RE : Presentation and Minutes of the DCS Working Group at Costa Mesa, March 6-7, 1990.

# PURPOSE OF SSWG

# ***DIAGNOSTIC FUNDAMENTALS***

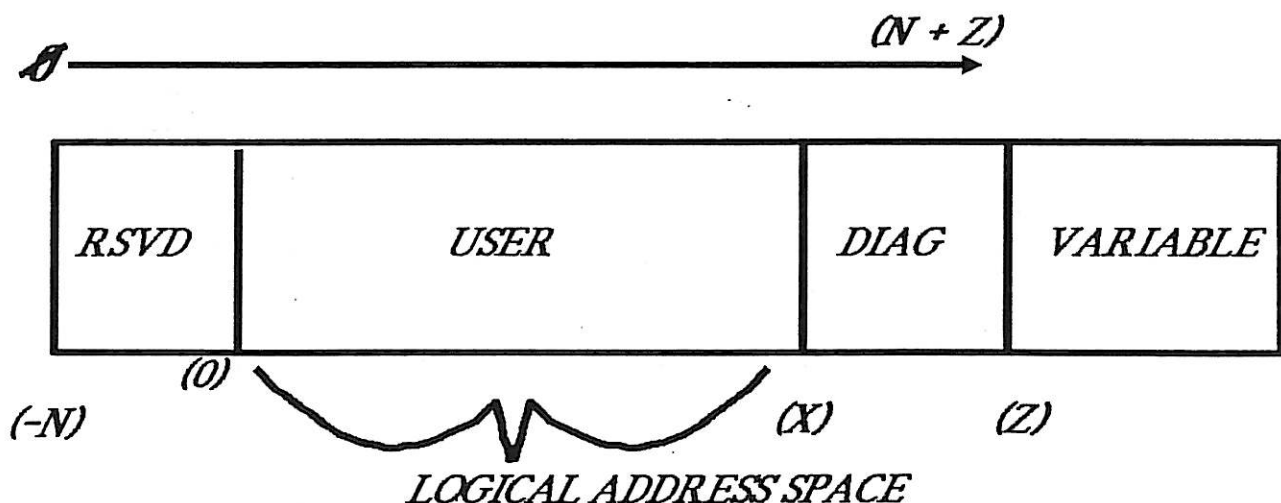
COMMITTEE RESPONSE: 1) Suggestion #1 should be changed to read "All Cylinders are reported, if possible, but cannot necessarily be read or written. 2) For suggestion #2, it was mentioned that a report of actual vs. nominal might be of use. Below is a diagram of the cylinder map in its crudest form: (possible delineation)
